World Forum for Harmonization of Vehicle Regulations

185th session

Proposal for the 02 series of amendments to UN Regulation No. 125 (Forward field of Vision of Drivers)

Submitted by the Working Party on General Safety Provisions *

"Annex 2

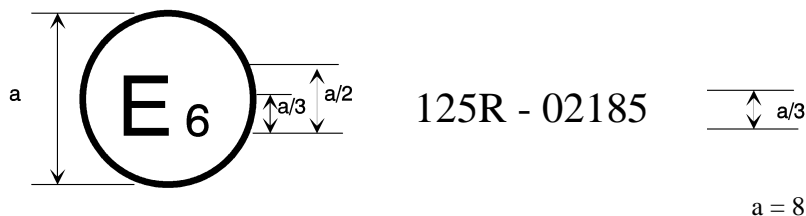
Annex 2, amend to read:

The above approval mark affixed to a vehicle shows that the vehicle type concerned has been approved in Belgium (E 6) with regard to the driver's forward field of vision pursuant to UN Regulation No. 125. The first two digits of the approval number indicate that the approval was granted in accordance with the requirements of UN Regulation No. 125 as amended by the 02 series of amendments."
